SOUTH TAHOE PUBLIC UTILITY DISTRICT

RECYCLED WATER FACILITIES MASTER PLAN

DRAFT ADDENDUM - JULY 2012

This Addendum EIR (AEIR) has been prepared by the District as the lead agency for the Project in compliance with CEQA and the CEQA Guidelines (California Administrative Code §1500 et seq.). The AEIR tiers off the FEIR and SFEIR by describing the revisions made to Master Plan projects 1 and 2 in Chapter 2, and updating environmental resource analyses to address potential effects of the revised projects.

A site plan showing the overall layout for the Project is provided as Figure 1.

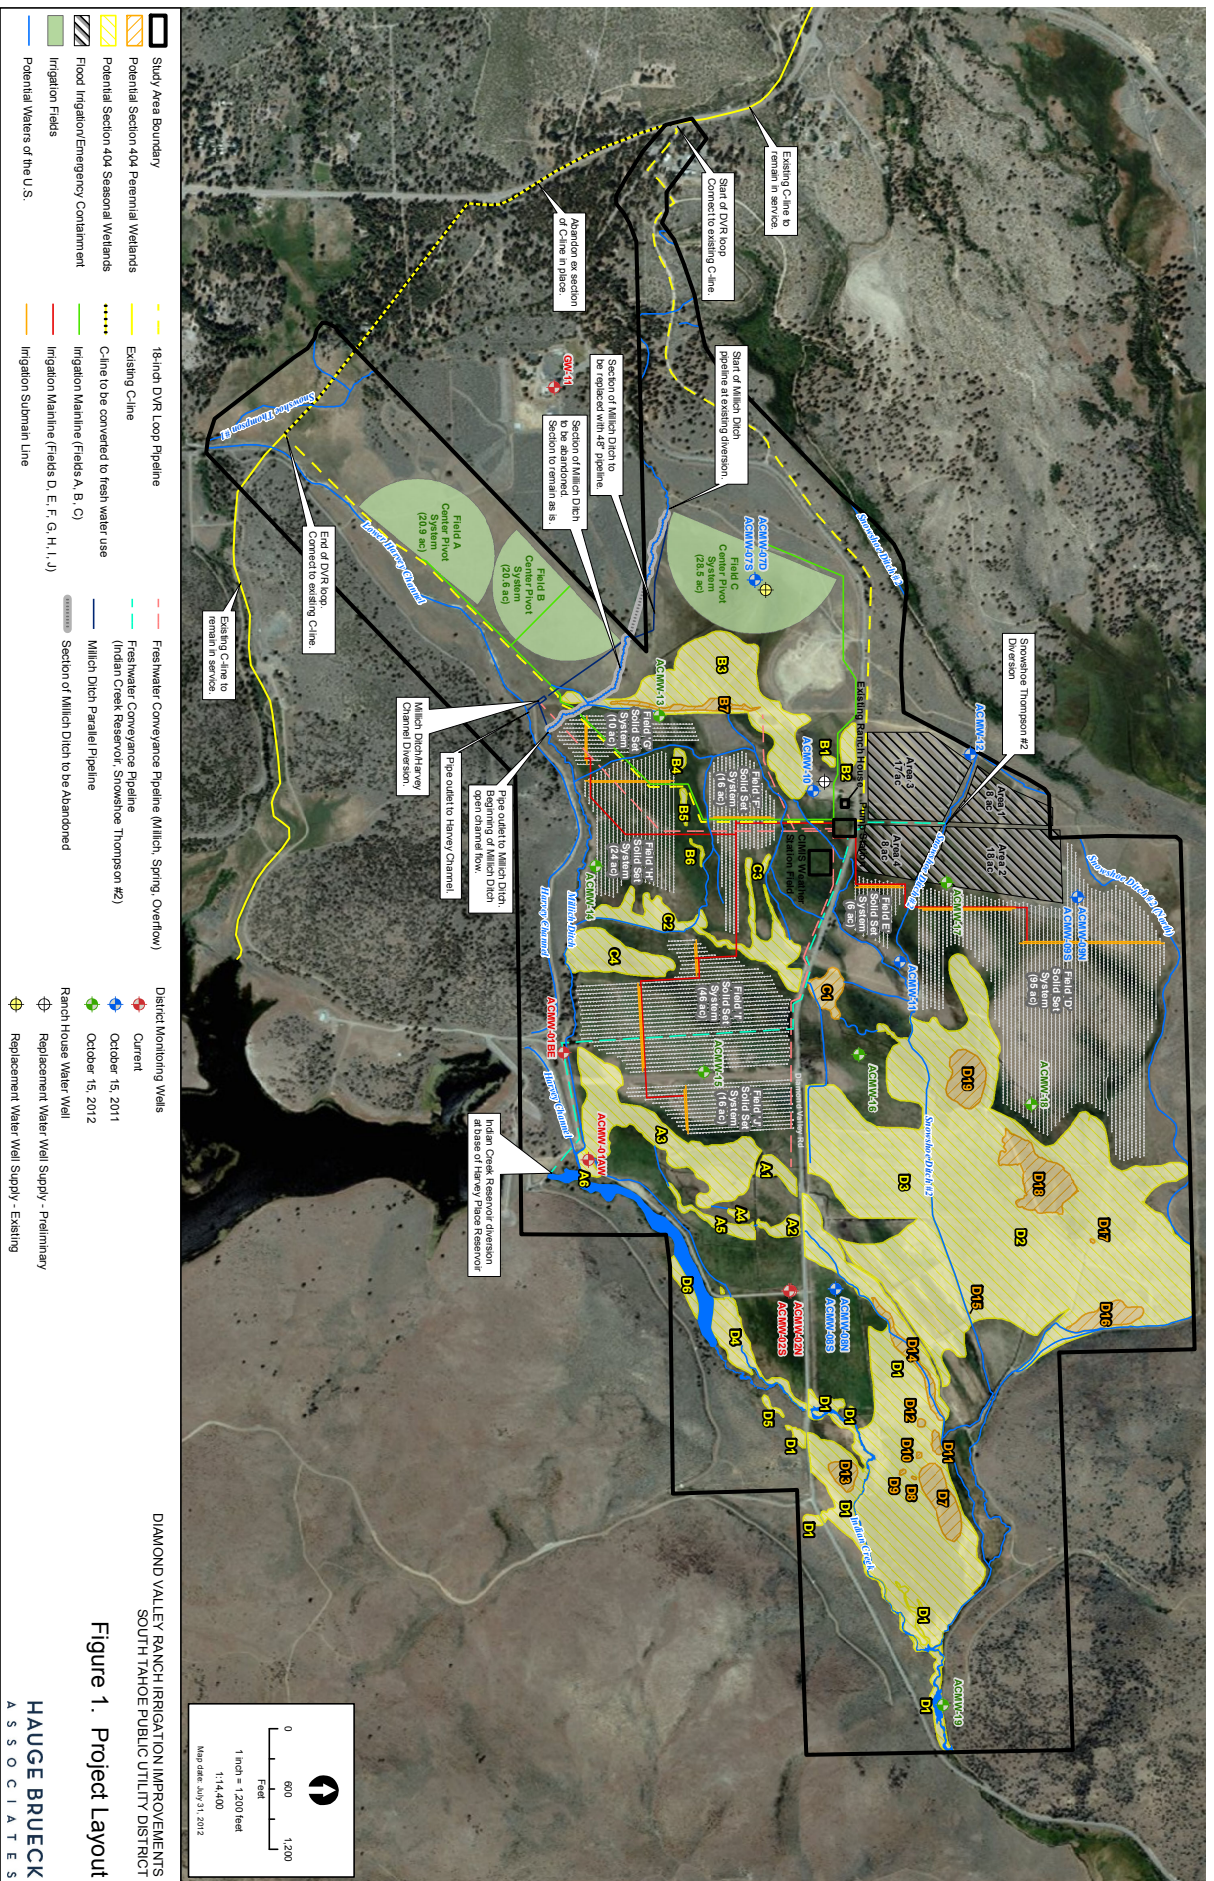
Three (3) Center Pivot Irrigation Systems and approximately 70 acres of accompanying surface irrigation fields (Fields A, B and C) are proposed for the project within the west ½ of Section 36, T 11N, R19E and the NW ¼ of Section 5, T 10N, R20E (Figure 1). Field A (20.9 acres), Field B (20.6 acres) and Field C (28.5 acres) will all be planted with alfalfa to be irrigated with freshwater initially and eventually with recycled water. The irrigation fields will not be mass-graded to produce level or constant-sloped areas. Rather, the sharp surface features such as swales, rock outcroppings, and steeper sloped areas will be smoothed out for improved irrigation application and harvesting of the crops. Each area will be improved with containment berms at the low-end of the fields to impede irrigation water runoff from exiting the fields. Cut-off ditches (head-ditches) will be constructed uphill of the application areas to keep non-irrigation surface flows from entering the fields. The irrigation fields do not cross any PWOUS or are located within 25-feet of any wetland. Construction and maintenance of the irrigation fields will not affect

designated wetlands or PWOUS. Previously under the old configuration, irrigation fields overlapped mapped wetland areas, thereby resulting in potential impacts to wetland areas as a result of construction activities

Seven (7) Solid Set Irrigation Systems and approximately 213 acres of accompanying surface irrigation fields (Fields D, E, F, G, H, I and J) are proposed for the project within the west ½ of Section 36, T 11N, R19E and the NW ¼ of Section 5, T 10N, R20E (Figure 1). Field D (95 acres), Field E (6 acres), Field F (16 acres), Field G (10 acres), Field H (24 acres), Field I (46 acres) and Field J (16 acres) will all be planted with alfalfa to be irrigated with freshwater initially and eventually with recycled water. All sub mains and laterals to the irrigation systems will be above ground poly vinyl chloride pipe laid in a shallow ditch with non-drain gaskets. The irrigation fields will not be mass-graded to produce level or constant-sloped areas. Rather, the sharp surface features such as swales, rock outcroppings, and steeper sloped areas will be smoothed out for improved irrigation application and harvesting of the crops. Each area will be improved with containment berms at the low-end of the fields to impede irrigation water runoff from exiting the fields. Cut-off ditches (head-ditches) will be constructed uphill of the application areas to keep non-irrigation surface flows from entering the fields. The irrigation fields do not cross any PWOUS or are located within 25-feet of any wetland. Construction and maintenance of the irrigation fields will not affect designated wetlands or PWOUS.

The Flood Irrigation/Emergency Containment Areas will consist of four level field areas bounded by earthen embankments (or cut slopes) along the perimeter (Area 1 = 8 acres, Area 2 = 18 acres, Area 3 = 17 acres and Area 4 = 8 acres) (Figure 1). During the irrigation season, the containment areas will be flood irrigated for alfalfa. The containment areas 3 and 4 may be used as a temporary impoundment for recycled water in the case of an additional storage need or other emergency condition. The containment areas will receive recycled water from a branch line off of the irrigation distribution system, but may also be filled directly from the DVR pipeline loop via a valved connection. Containment areas 1 and 2 will

The FI/EC areas are in an area that is outside the are of any delineated wetlands and does not impact any PWOUS.

Revisions to the project as noted in Section 2 above were made as a result of the US Army Corps of Engineers approved wetland delineation as depicted on Figure 1. Relocation of the irrigation fields and flood irrigation/emergency containment areas away from the wetland areas decreases impacts to wetlands and waters of the US. The 2009 EIR and 2011 SEIR identified significant proposed impacts resulting from the Recycled Water Facilities Master Plan. These impacts are identified in Table 3-1:

DIAMOND VALLEY RANCH IRRIGATION IMPROVEMENTS
SOUTH TIAHOE PUBLIC UTILITY DISTRICT
Figure 2. PWOUS Crossings

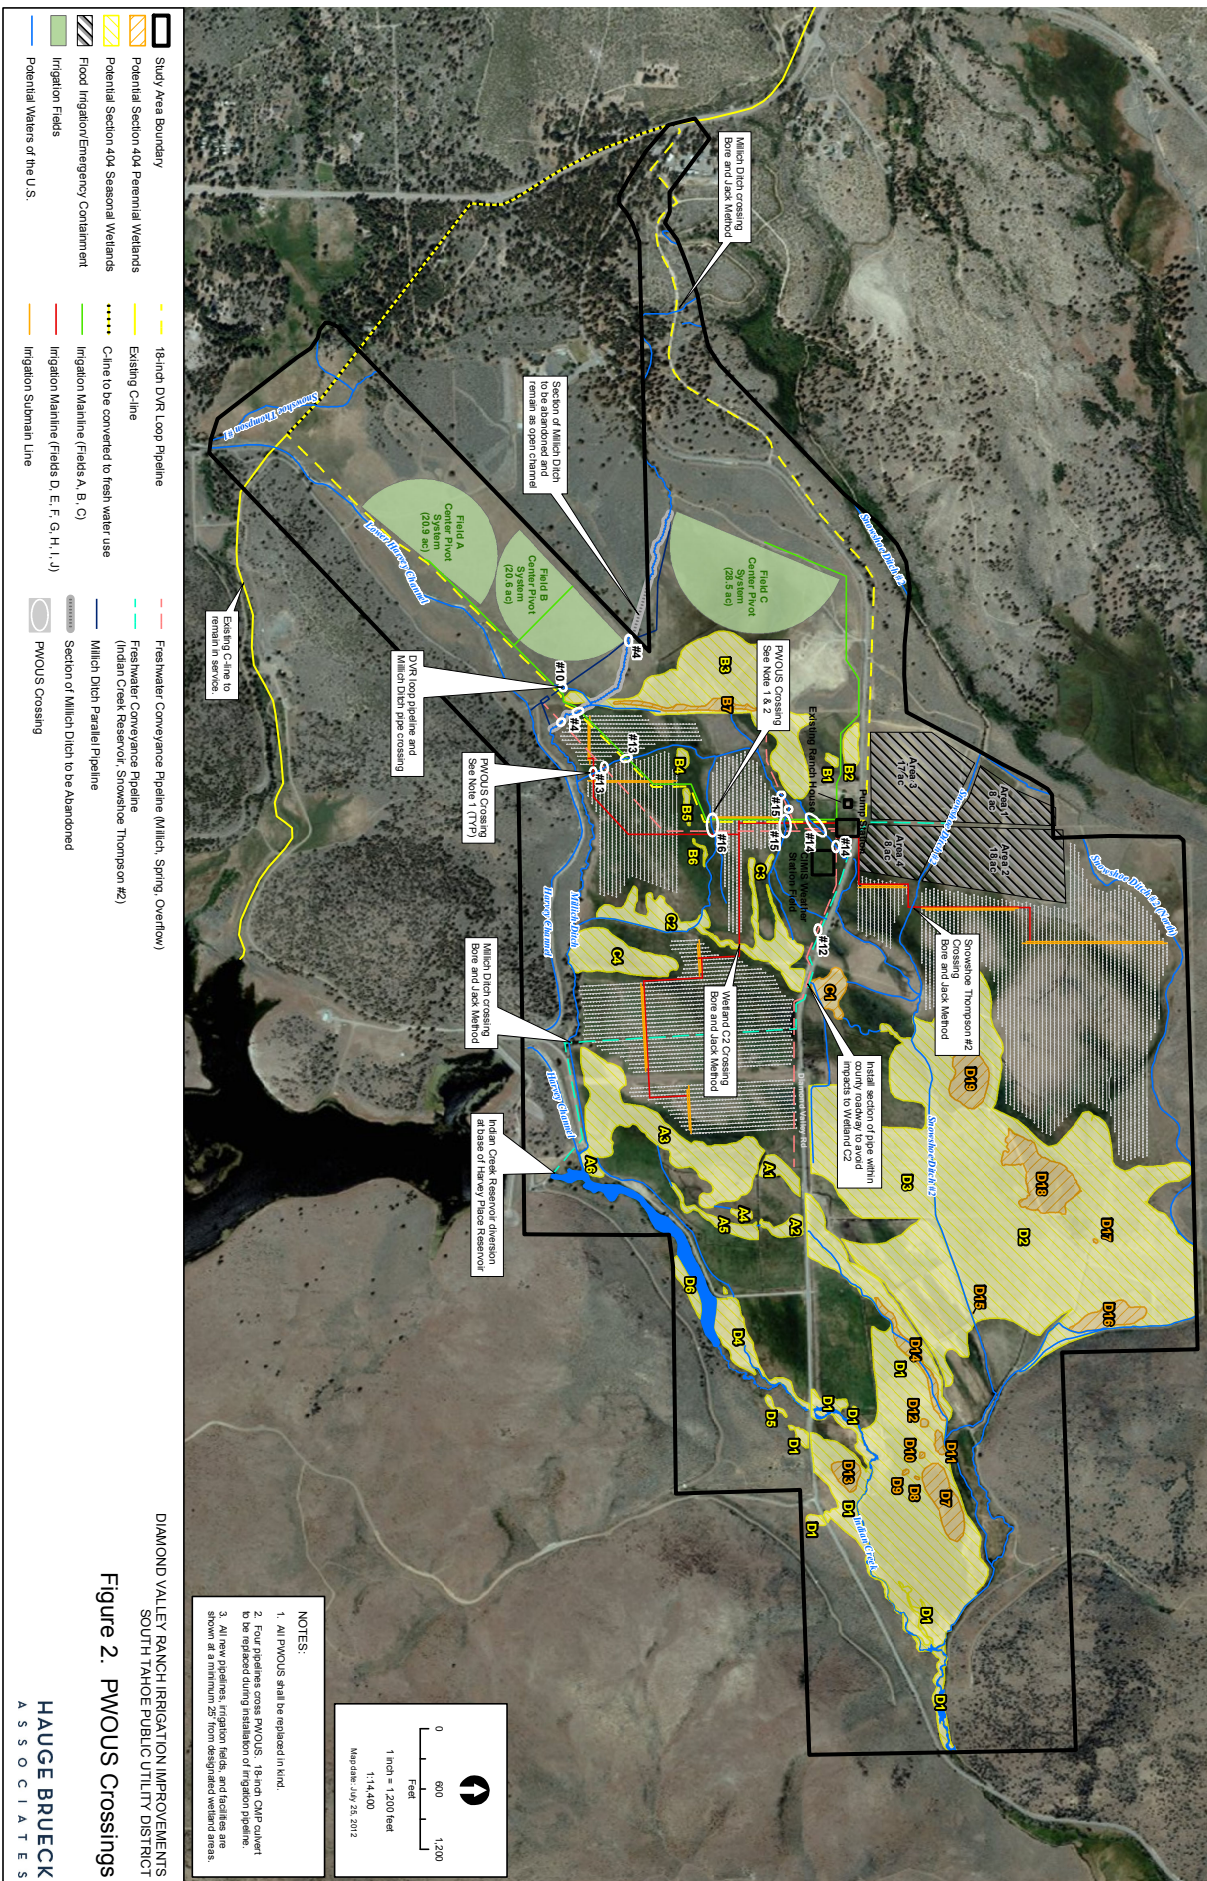
Figure 2 shows the irrigation mainline to Fields A and B crossing four minor irrigation ditches between Diamond Valley Road and Wetland B3, which are identified as PWOUS #s 13, 14, 15 and 16. The average width of each of these features is 1-foot. The irrigation mainline to fields F, G, and H will cross four minor irrigation ditches, which are identified as PWOUS #s 13, 14, 15 and 16. Construction of the

mainline across these features will be performed using open cut excavation methods. All minor irrigation ditch crossings will be performed during periods of no-flow, when the channels are dry. Soil erosion and sediment controls will be used in accordance with Section 3 Best Management Practices of the project SWPPP (AECOM, 2011). Any temporary fills will be removed from the ditch and the affected areas returned to pre-construction elevations. If available, the top 1-foot layer of sod and topsoil within the crossing will be salvaged and replaced once the crossing construction is completed. The 18-inch mainline to Fields I and J will cross Wetland C2. This crossing will be installed by bore and jack construction method in order to avoid disturbance of the wetland.

Figure 2 shows the piped section of Millich Ditch crossing one minor irrigation ditch (identified as PWOUS # 10) and the abandoned section of Millich Ditch between the existing Millich #2 Diversion Structure and the new Millich Ditch/Harvey Channel Diversion. The average width of the minor irrigation ditch is 1-foot; the average width of the abandoned section of Millich Ditch is 10-feet. Construction of the piped section of Millich Ditch across these features will be performed using open cut excavation methods during periods of no-flow, when the channels are dry. Soil erosion and sediment controls will be used in accordance with Section 3 Best Management Practices of the project SWPPP (AECOM, 2011). Any temporary fills will be removed from the ditch and the affected areas returned to pre-construction elevations. If available, the top 1-foot layer of sod and topsoil within the crossing will be salvaged and replaced once the crossing construction is completed. The estimated total PWOUS crossing length and excavation volumes for construction of the parallel pipeline are estimated at 11 lf and 8.8 cubic yards, respectively.

No impacts to wetland areas will result from relocating the irrigation fields to the proposed locations. As noted in the Section 2 above and shown on Figure 2, the irrigation distribution pipelines will cross a total nine potential waters of the US, resulting in a total of 36 square feet of impact from irrigation mainline crossings. Other locations where the irrigation distribution lines cross wetland areas (e.g. en route to Fields I and J) jack and bore methods will be used to install the pipeline without disturbing the wetland. Construction and use of the Millich Ditch parallel pipeline will not have any adverse effects to resources in the area. The existing ditch is to be abandoned in place to allow for collection of surface flows. The center pivot irrigation system will not have any additional impacts to resources as they are not in different locations as compared to the locations previously analyzed in the 2011 SEIR. The total surface area of the proposed impacts to potential waters of the united states from the project is estimated at less than 0.10 acre. These impacts are temporary and will be minimized using Best Management Practices, compliance measures, standard practices and mitigation measures.
